CALIFORNIA COASTAL COMMISSION

STAFF REPORT: APPEAL
DE NOVO ACTION (CONTINUED)

APPEAL NUMBER: A-3-MAR-96-094

PROJECT DESCRIPTION: **Marina Dunes Resort:** 112 vacation units (average unit: 1000 SF); 71 hotel units (average unit: 955 SF); 1 manager unit; total square footage of units 175,499. Total building square footage for ancillary facilities 60,000 including restaurant/tavern 571 seats, conference center, offices, retail, spa and cosmetic surgery clinic, recreation building. Parking garage 12,827 SF. Other facilities: 2 tennis courts, pools, 18 public parking spaces and beach boardwalk access. 6.5 acres habitat restoration in form of dispersal corridors and buffers. Subdivision into four parcels: Parcel 1, 1.72 acres, conference facility; Parcel 2, 2.88 acres, restaurant/spa building; Parcel 3, 3.40 acres, hotel and main lobby buildings; Parcel 4, 11.40 acres, vacation unit buildings and recreational building, pools, tennis courts.

FIGURE 1 - TYPICAL UNIT SIZE COMPARED TO MARINE DUNES RESORT UNIT SIZE

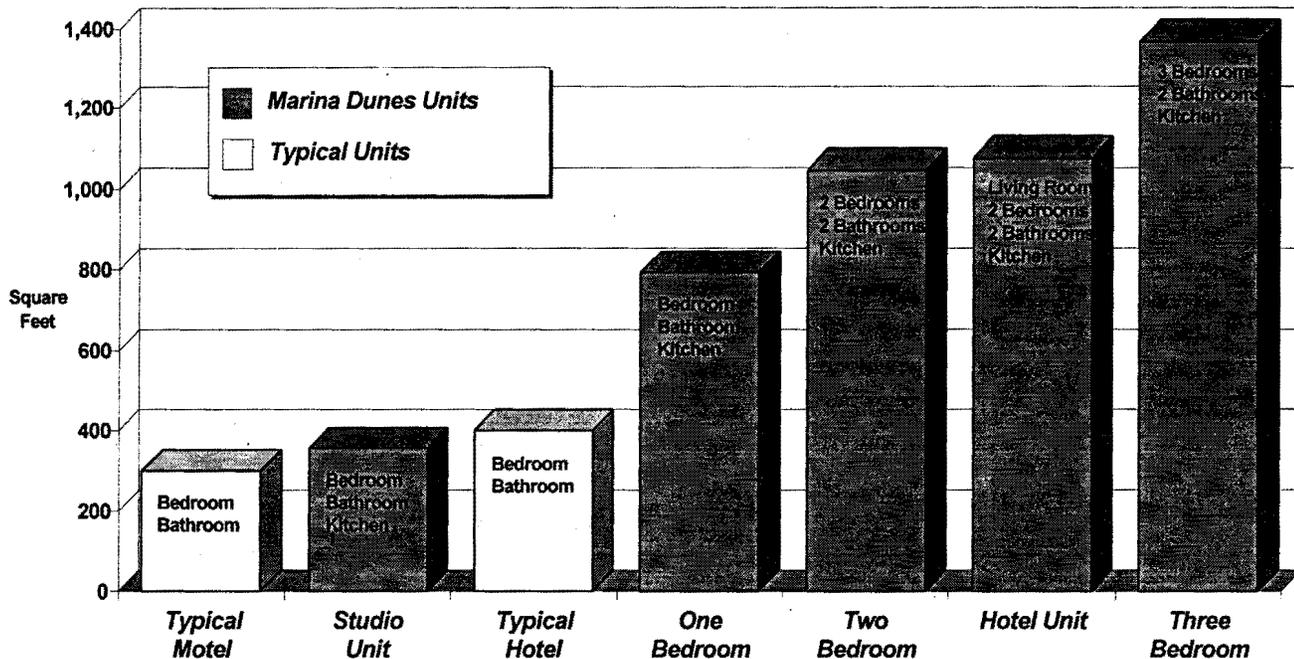
Because of the size of the units, the proposed development will support more people and automobiles (hence greater intensity) per individual unit than the unit count of 184 would ordinarily infer. Where two visitors per unit is common for a typical Monterey or Santa Cruz room, the Marina Dunes Resort suites will support more than double that number and, in the case of the largest units, triple the number. In terms of size of units the proposed Marina Dunes Resort can not be considered a lower intensive use compared to the urban areas of Monterey and Santa Cruz and is, therefore, not consistent with the Land Use Plan. If "less intensive" were only construed to mean less than average unit size, then the proposed project's units should be downsized to less than 400 sq. ft.

FIGURE 2 UNITS PER ACRE COMPARISON

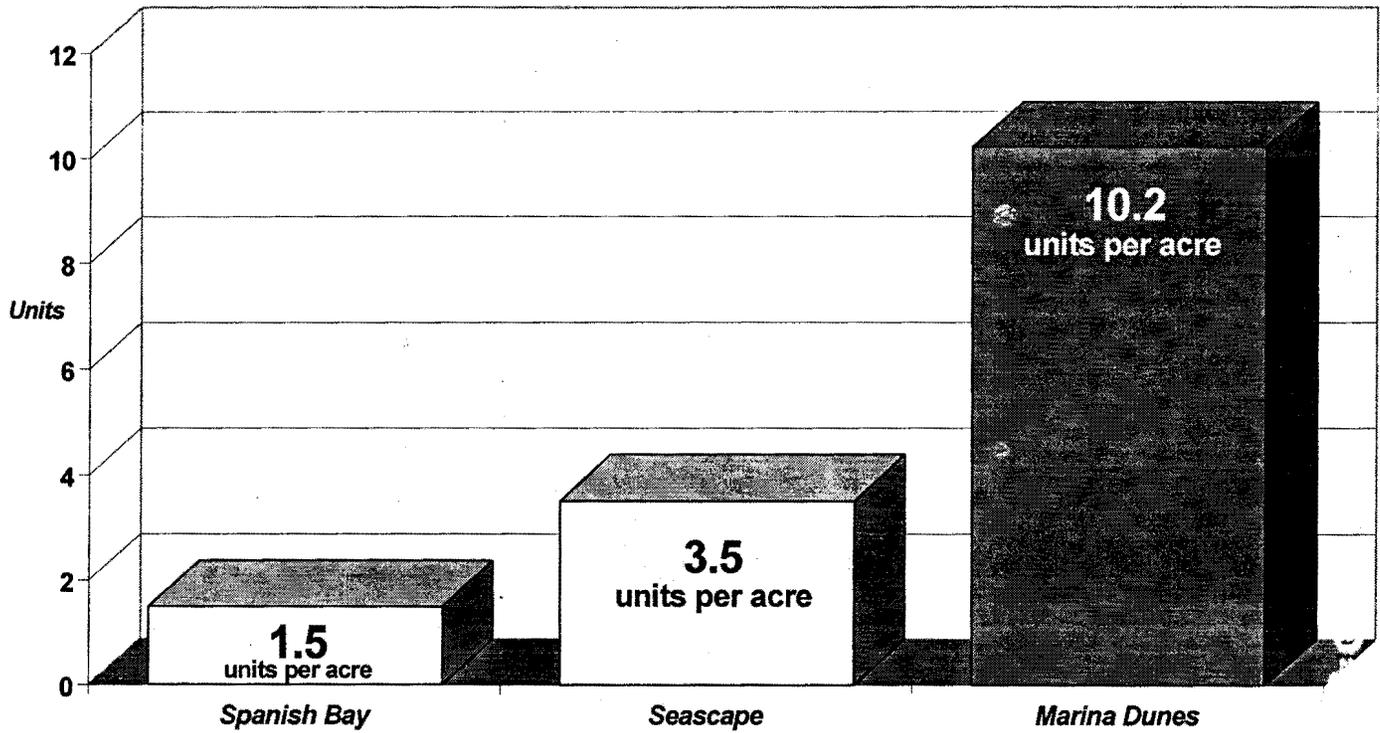
Table 6, compares the above projects with the Marina Dunes Resort and with the typical urban Santa Cruz/Monterey motel/hotel. The table and Figure 2 show that, regarding number of units per acre for the most comparable types of resort developments (Spanish Bay and Seascape), the proposed Marina Dunes Resort is at least three times the density of the other two facilities and, therefore, is not a low intensive use and is inconsistent with the Local Coastal Program. Table 6 and Figure 3 also shows that the Marina Dunes Resort has several times the square footage of ancillary facilities per acre as does either of the other two resorts.

EXHIBIT NO. 4
APPLICATION NO. A-3-MAR-96-94
VISUAL SIMULATIONS
V9

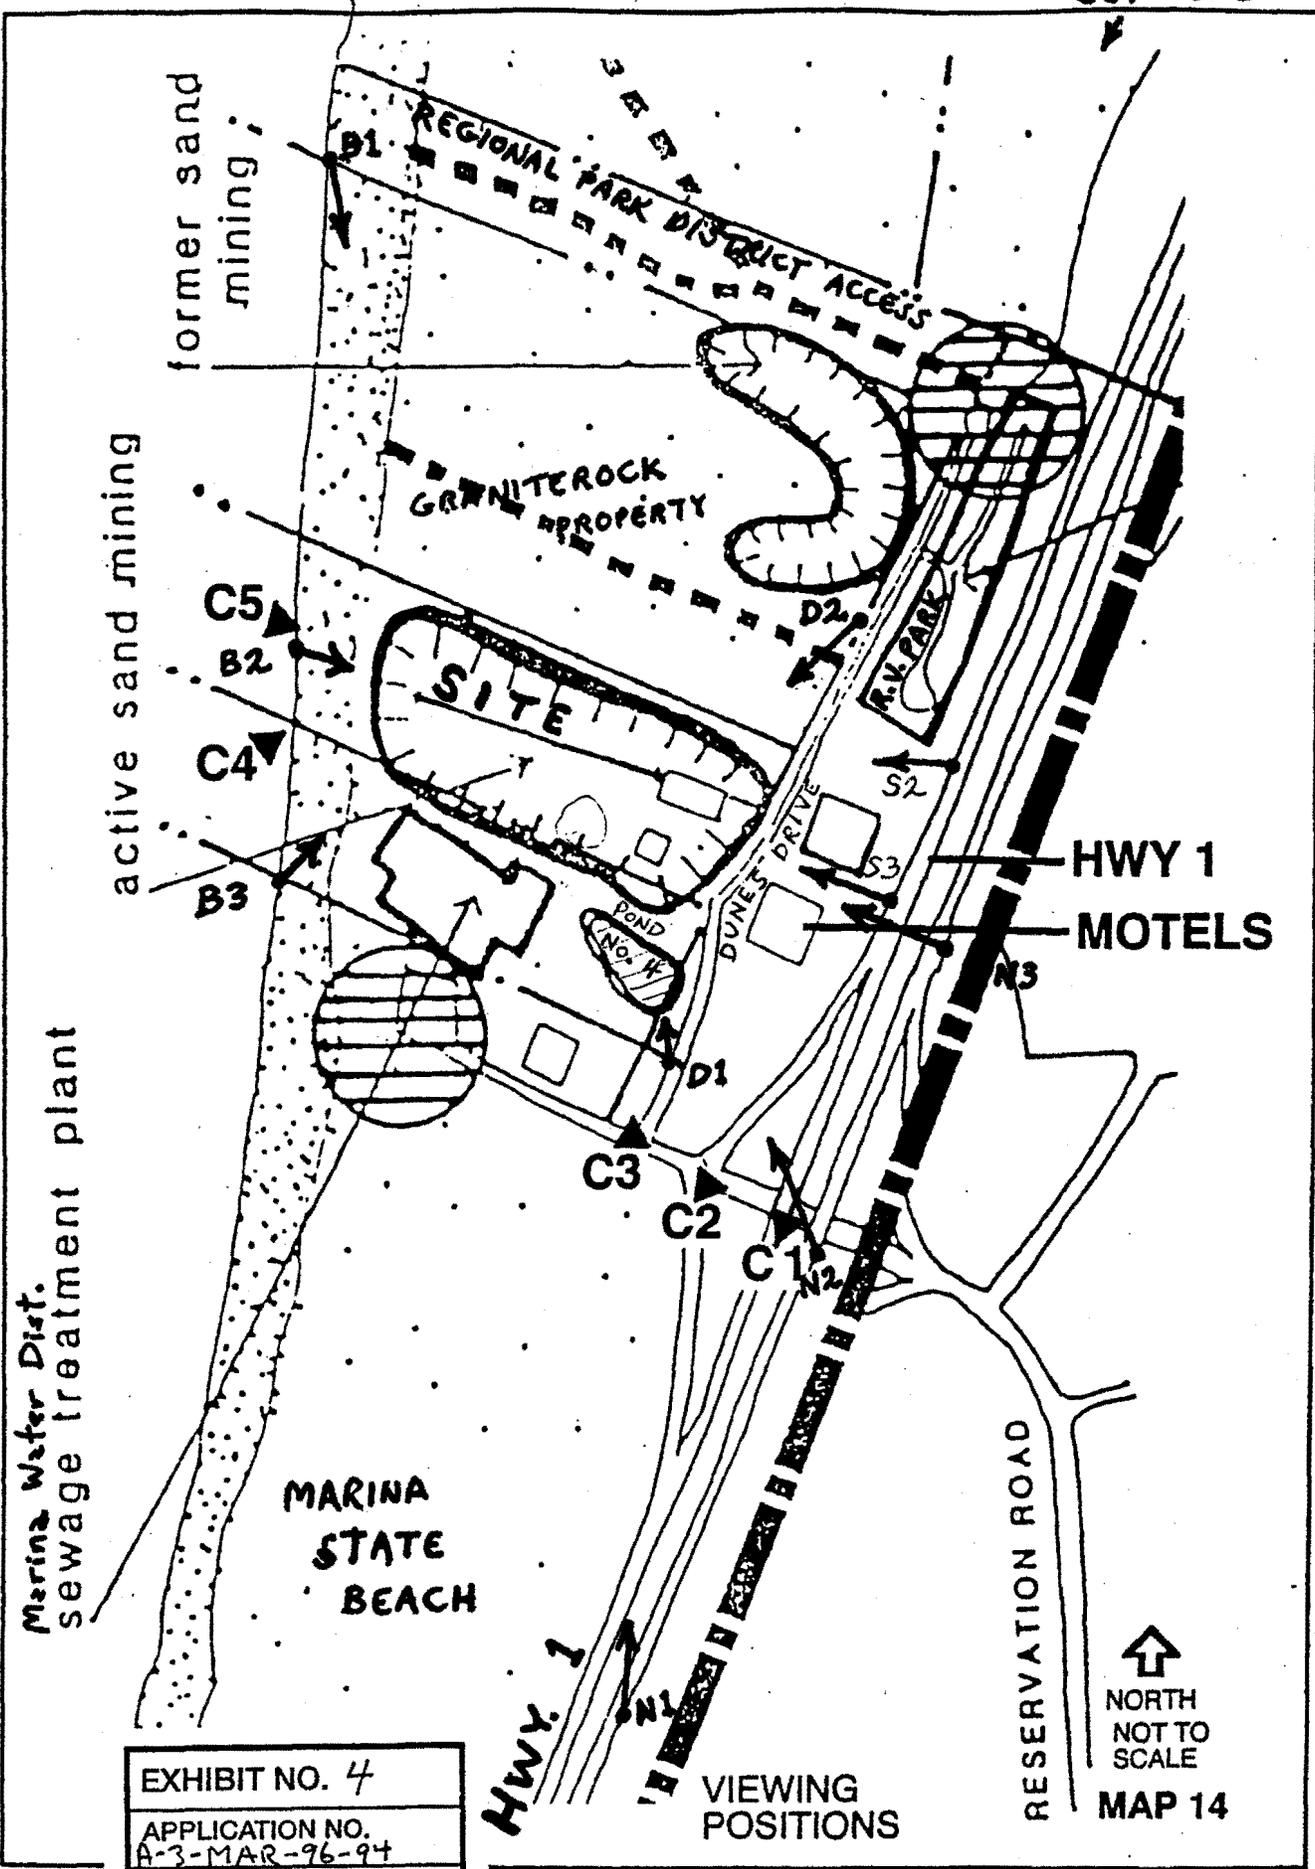
- c. No structures shall be visible from the mean high tide line of the beach below that portion of the bluff located on project site, except sand fences, habitat enclosures, and boardwalks as needed to insure site stability and provide for landscape restoration; and a beach access stairway pursuant to the Final Plans. (Viewing position B2 on Exhibit 4 map.)

- d. No structures shall be visible from the mean high tide line of the beach ~~below that portion of the bluff located on project site~~, except sand fences, habitat enclosures, and boardwalks as needed to insure site stability and provide for landscape restoration; and a beach access stairway pursuant to the Final Plans. (Includes viewing position B2 on Exhibit 4 map.)
